WALKER MINING COMPANY

RECOMMENDATION FOR DEVELOPMENT WORK

Mine WALKER

Ore Body Piute

No. 22

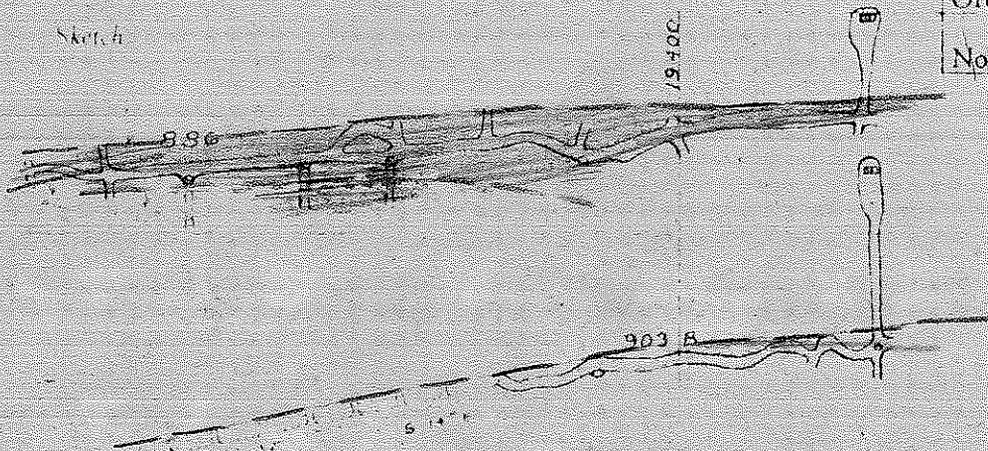
Extend 903B DS on lines S 14° E and crosscut to footwall every 50'. Level must be off of footwall for scraper stopes. Lines to be changed as guided by footwall.

Miller Mining Company
712 Orebody
Scale 1" = 50'

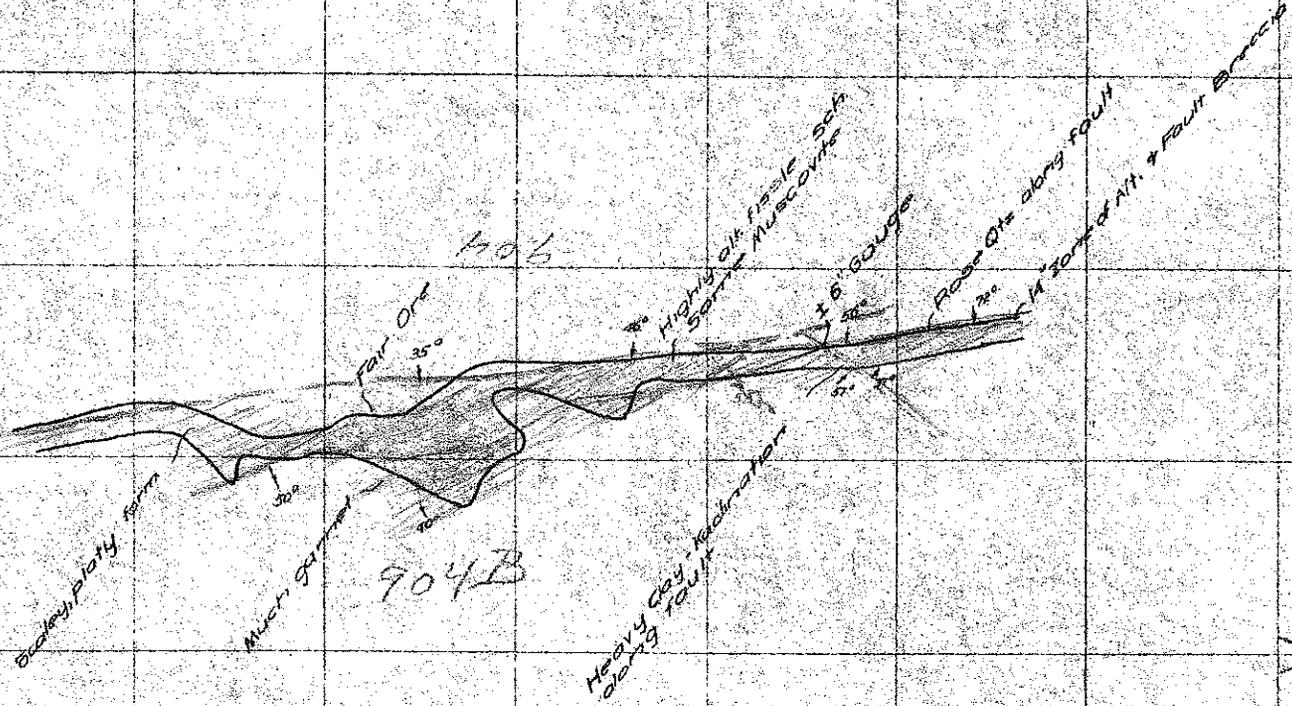
The composite sketch and section of the 517 footwall fissure zone of the 712 Orebody gives a picture of development to date. 619E has been stopped for the time being. Mineralization was so weak and scattered, that it seemed wiser to see what the extension of 471C beyond 559B raise would bring. Although we have ample information and mineralization to warrant a raise being driven, in preparation of mining ground under the 500 Level, we may have to extend 654E to NW to determine whether the vein steepens or pinches below the 500 Level.
